# MEMO

**To:** Kristopher Byrd, Well Construction and Compliance Section Manager  
**From:** Travis Kelly, Well Construction Program Coordinator  
**Subject:** Review of Water Right Application LL-1826  
**Date:** May 14, 2020

Application # LL- 1826

TO: Water Rights Section Date: 5/7/2020  
 FROM: Groundwater Section Travis Brown  
Reviewer's Name  
 SUBJECT: Application LL- 1826 Supersedes review of \_\_\_\_\_  
Date of Review(s)

Well Construction Diagram

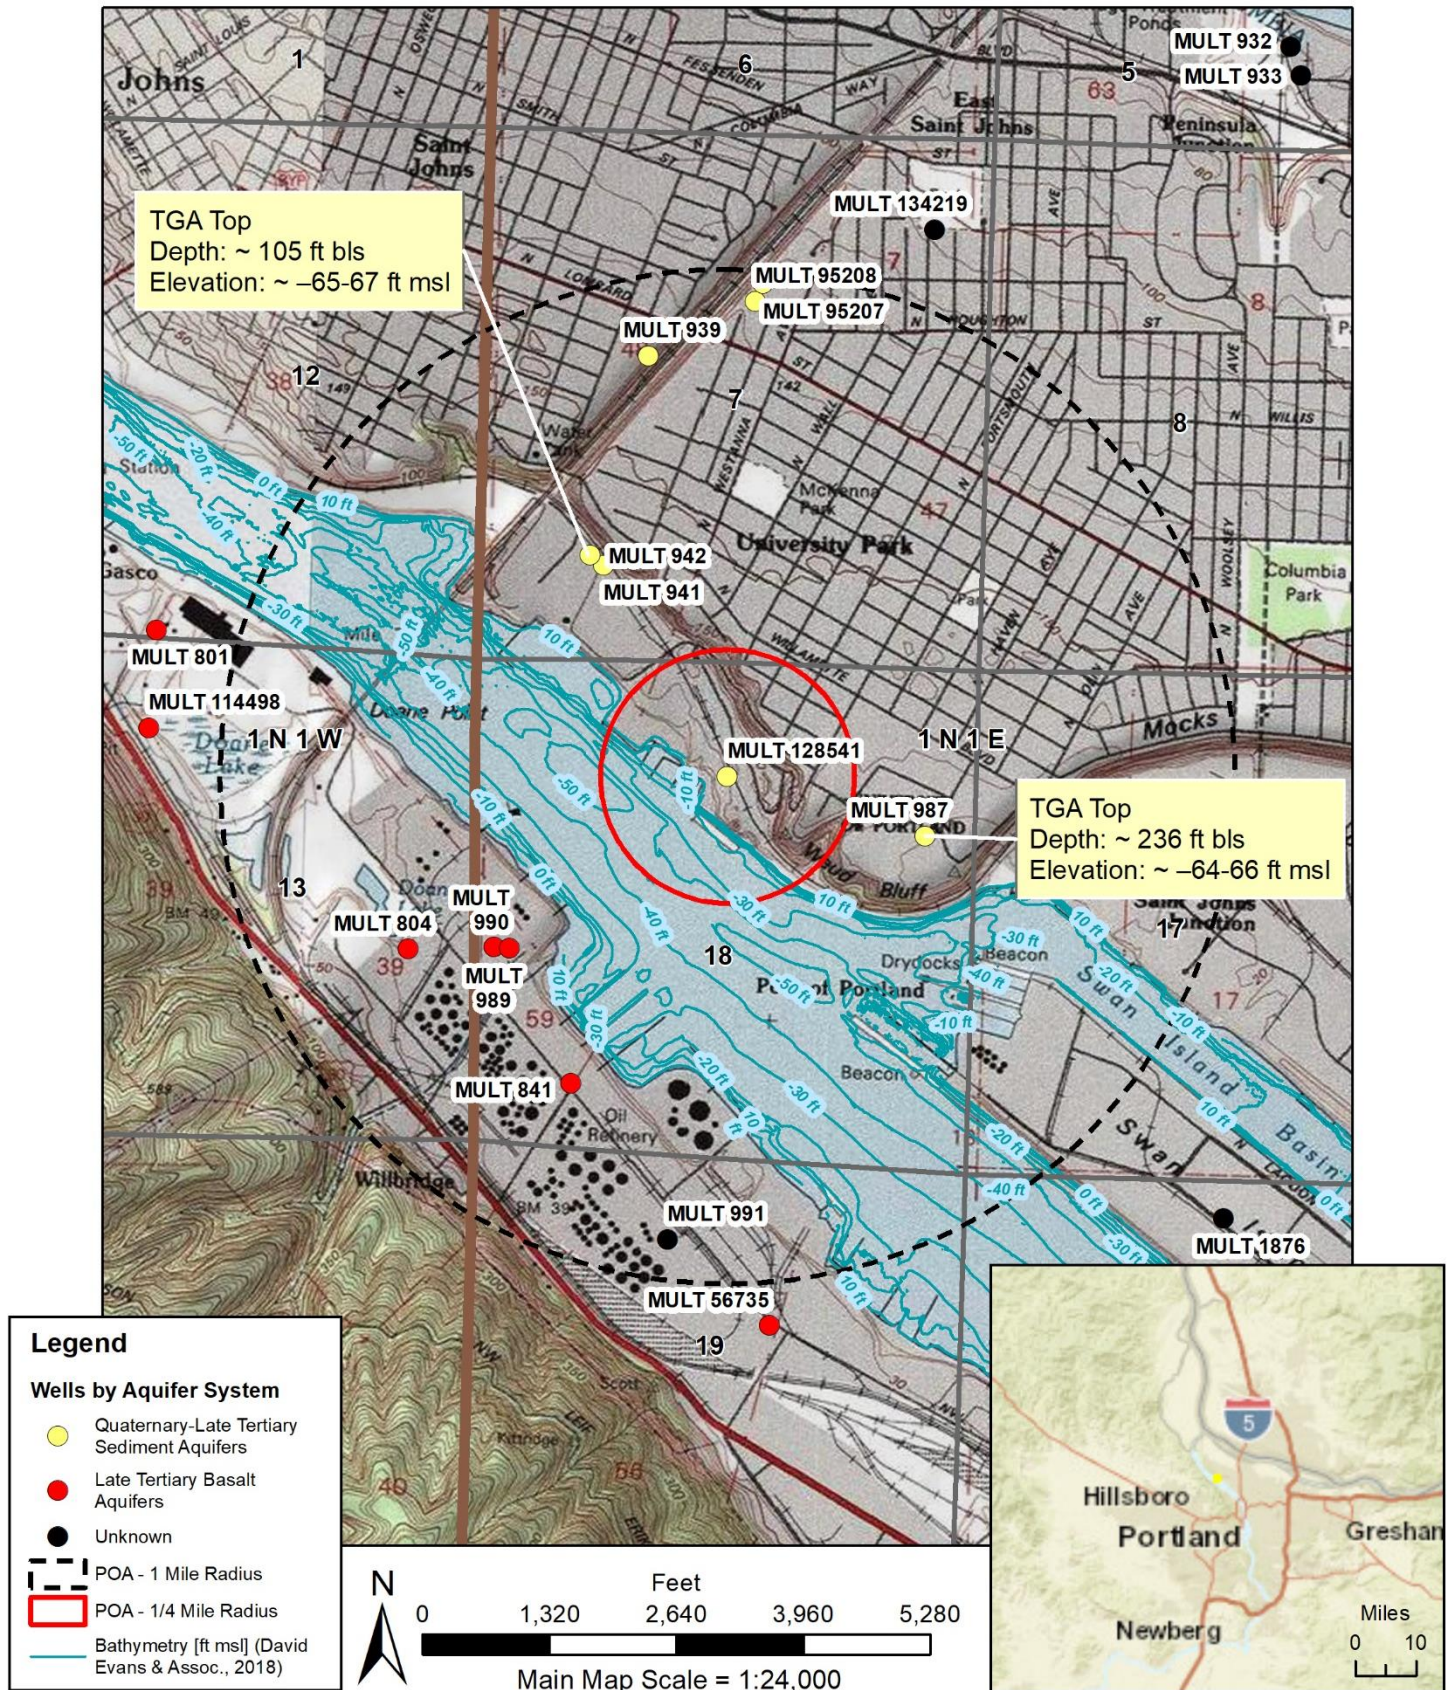
D3. **THE WELL construction deficiency or other comment is described as follows:** A well construction deficiency regarding the seal for MULT 128541, originally identified in the review for LL-1807, appears to be unresolved as the Department has not yet received an alteration log confirming that the well has been appropriately repaired.

Based upon the well log for MULT 128541, the upper oversized (12-inch diameter) borehole extends only from land surface to 18 ft below land surface (bls) – into “black sand” as noted on the well log (see attached Well Construction Diagram). Below this, the borehole is noted as being 8 inches in diameter with an 8 inch diameter casing – meaning there is no annular space into which the bentonite sealing material could have been placed to create an effective seal. From 18 to 20 ft bls, the log describes the material as “grey sand”. From 20 to 93 ft bls, the log describes the material as “grey silty clay”. The well is screened from 109.75 to 125.5 ft bls, through what is described as “sand gravel & water”. Based on the requirements of OAR 690-210-0140, “Sealing of Water Supply Wells in Unconsolidated Formations with Significant Clay Beds”, the upper oversized borehole should extend “at least five feet into the clay interval overlying the water-bearing zone” or to a depth of at least 25 ft bls based on the well log.

The insufficient seal in MULT 128541 is of particular concern because the well, as currently constructed, may provide a potential pathway for cross-contamination between the shallow fill and sediments of the Unconsolidated Sedimentary Aquifer (USA) and the deeper Troutdale Gravel Aquifer (TGA) at this site – see Section B3, above, for more details.

Applicant's Well #5 (MULT 128541): Based on a review of the Well Report, Applicant's Well #5 does not appear to comply with current minimum well construction standards (See OAR 690 Division 210). The problem is that the Well Report indicates that the well was sealed to a depth of 18 feet below land surface into Sand. In order to meet minimum well construction standards, the well must be resealed to a minimum depth of 25 feet below land surface, which is at least five feet into the Grey Silty Clay.

My recommendation is that the Department **not issue** a Limited License for Applicant's Well #5 (MULT 128541) unless it is brought into compliance with current minimum well construction standards or information is provided showing that it is constructed to meet current minimum well construction standards.
